Inventor(s): COURTEMANCHE, Alain
Application No.: 10/799.697
Filed on: 15 March 2004
Title: LIQUID MANURE SPREADING TOOL BAR
Group Art Unit: 3752
O/ref.: 005170-0017

REQUEST FOR REINSTATEMENT

AMENDMENT

FIG. 1
(PRIOR ART)

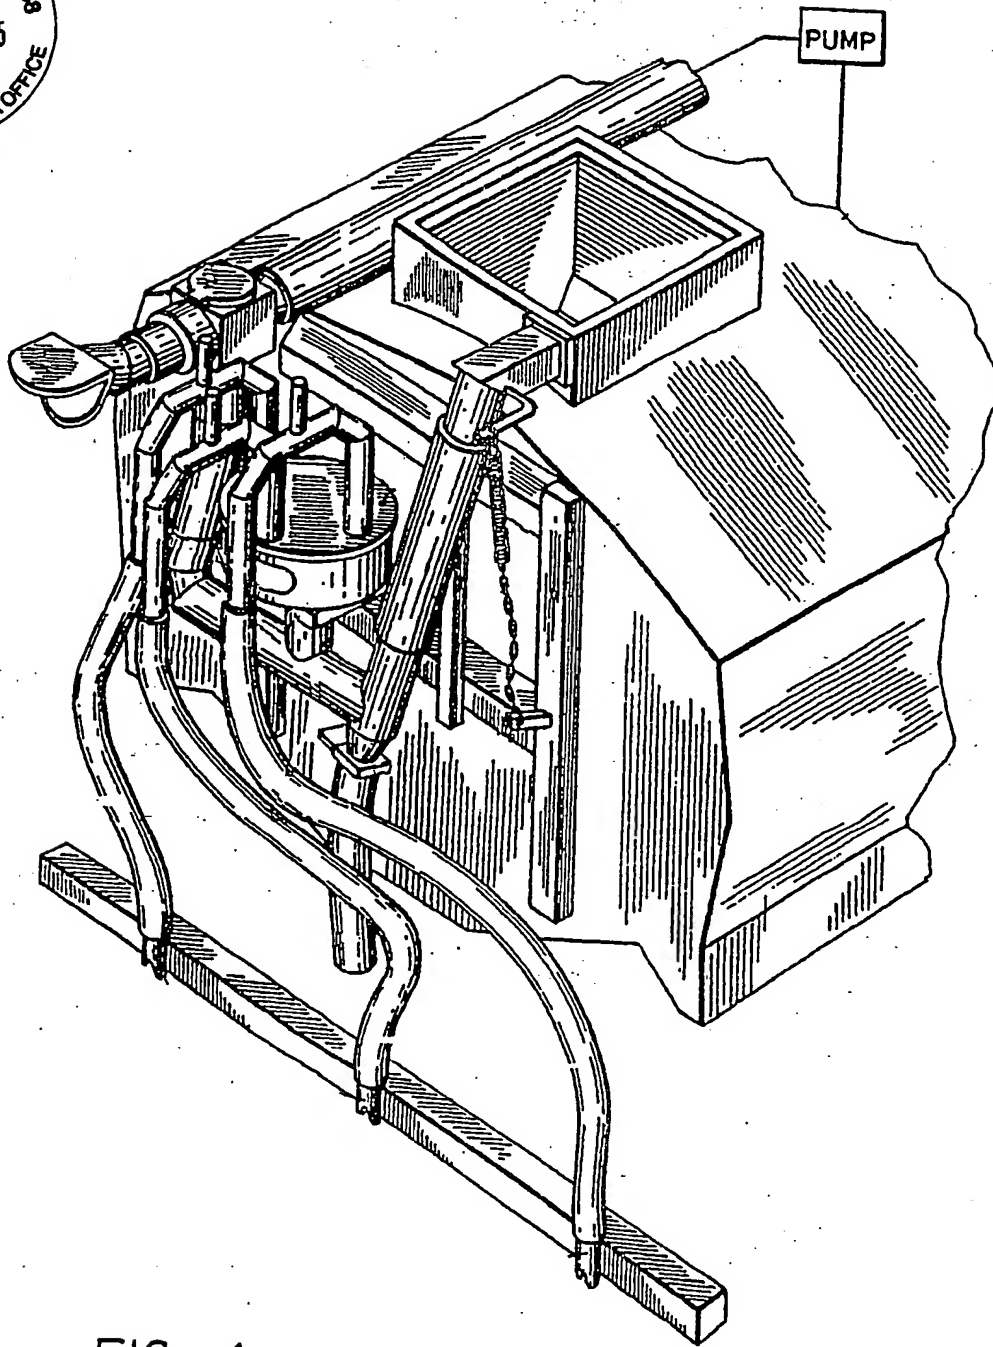
With respect to the pump, the Examiner may refer to Figure 1, which illustrates the basic structure of a liquid manure spreader provided with a distributor that the present invention is intended to improve. This prior art manure spreader is illustrated with a pump, which, from a practical standpoint, is usually positioned at the front of the manure tank and cannot therefore be seen from the rear side of the spreader. It is worth noting that the outlet of the pump leads to the outlet pipe (17) already shown in Figure 3, as is disclosed on page 5, lines 24 to 26 of the original specification.

FIG. 3

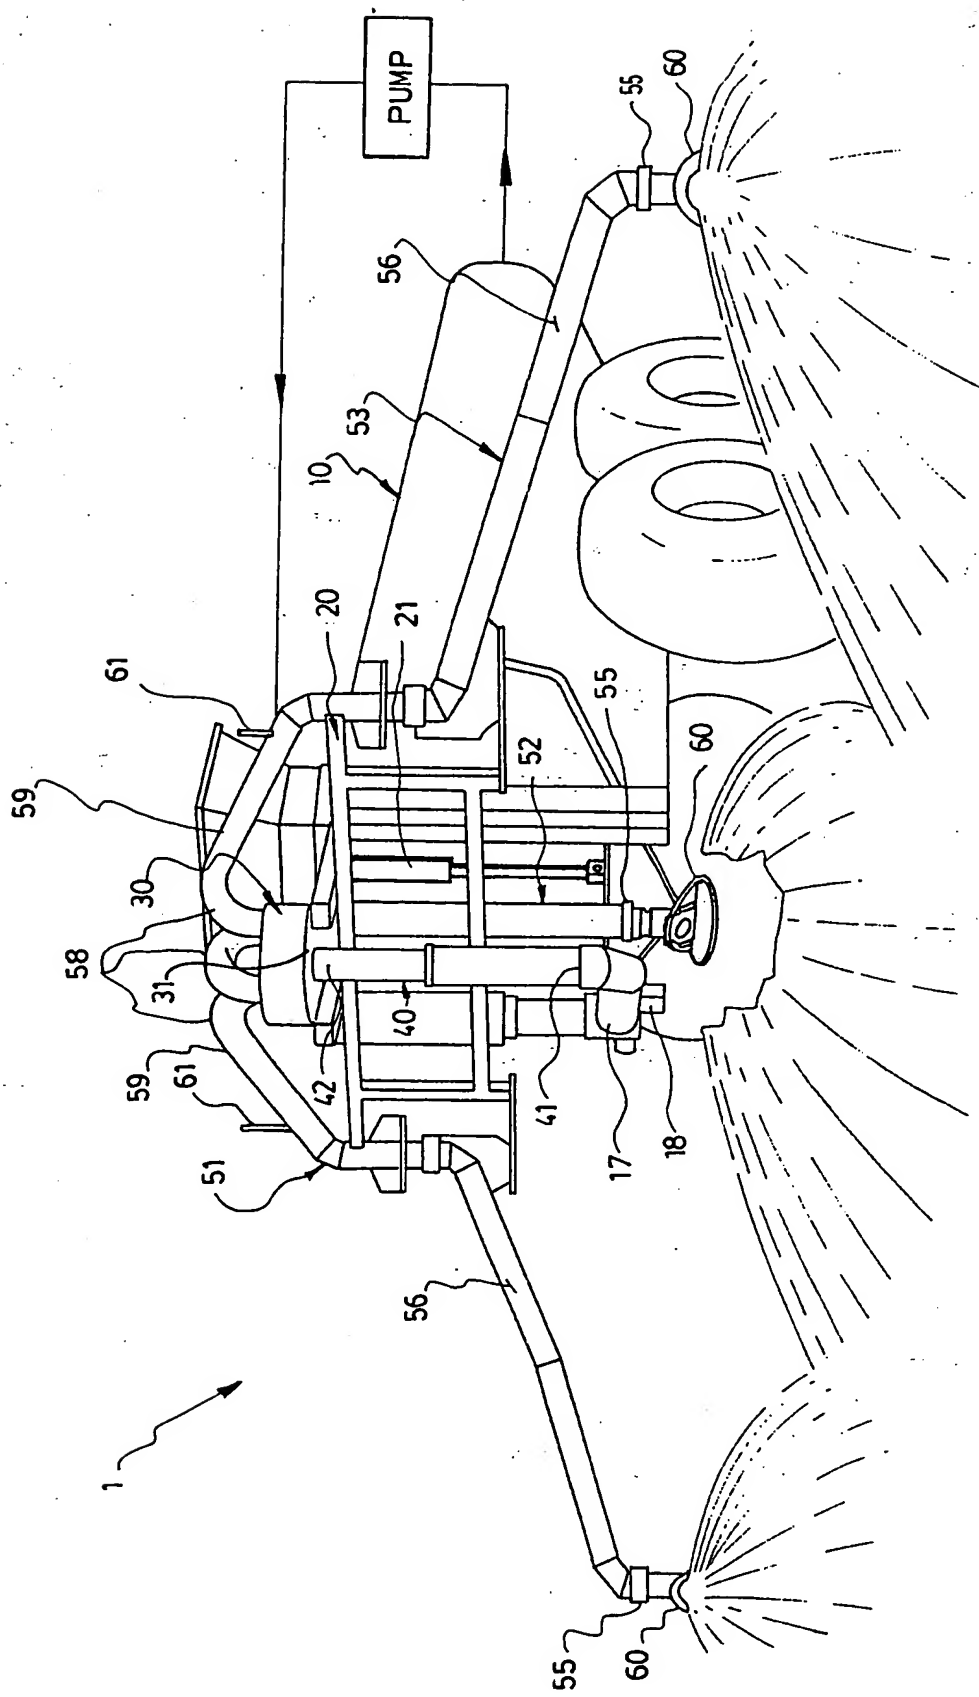
The Examiner's objection to the drawings as set forth in paragraph 2 on pages 2 and 3 of the Action, has been noted.

In order to overcome this objection, Figure 3 of the drawings has been amended in order to show :

- the pump referred to in claim 1,
- the adjustable sizing outlet referred to in claim 3, and
- the hydraulic lift system referred to in claim 8.

It is also believed that the amendment made to Figure 3 in order to better illustrate the way the deflector (60) may be used to adjust the size of the outlet (55) of each of the discharge pipe is quite obvious in view of what was already shown in Figure 3. To confirm that such is not an introduction of new matter, a photograph of the manure spreader according to the invention as presently manufactured and sold by the Applicant, is enclosed herewith. Such a photograph clearly shows such an outlet. The Examiner

With respect to the hydraulic lift system, a proper illustration of such a system has been added to Figure 3. It is believed that the way such a lift system may be used to lift up and down the supporting frame of the distributor is quite obvious and that the addition of such a system as item 21 in Figure 3 of the drawings should not be considered as an introduction of new matter, especially in view of what is disclosed on page 7, lines 10 to 12 of the original specification.

It is believed that the amendment made to Figure 3 overcomes the Examiner's objection and should not be considered as an introduction of new matter.
